**Re: IWWC #A20-7.1 / 5 & 21 Toelles Road & Wharton Brook
Pfizer Inc. Soil Remediation Project**

On behalf of Pfizer Inc. (Pfizer), Woodard & Curran (W&C) is providing this letter in response to Milone & MacBroom, Inc. (MMI) letter dated November 13, 2020 regarding the subject Inland Wetlands and Watercourses Commission (IWWC) permit application. MMI's letter provided a series of comments and this letter provides responses to those comments. MMI's comments are provided below in bold and the responses follow each comment. A new sheet presenting cut/fill analysis has been added to the set of plans and is also provided as an attachment to this letter. An invasive species management plan has also been attached to this letter.

TREE PROTECTION

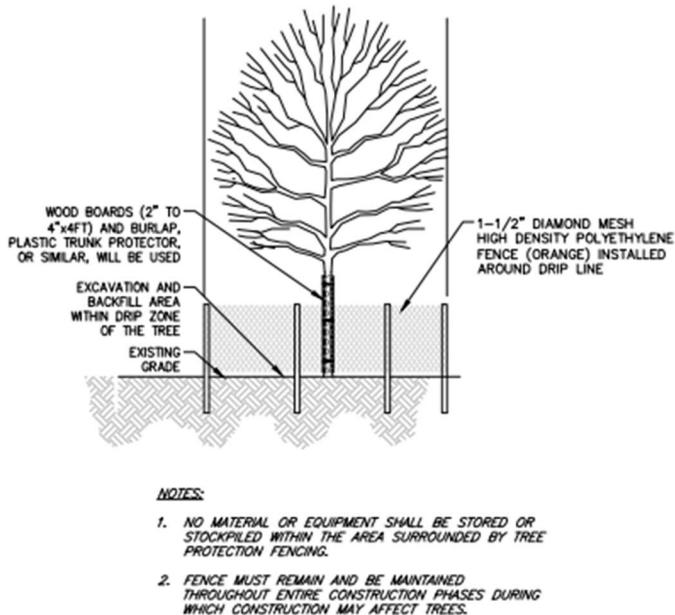
- C6. The applicant should provide tree protection details for those 15-inch DBH trees that will remain within the wetland remediation area. Damage to tree trunks and roots must be minimized to the maximum extent practicable.

Prior to beginning site construction, the Contractor will be required to submit a tree protection plan for review. The following tree protection notes have been added to Sheet G-001.

The following tree protection detail has been added to Sheet C-202.
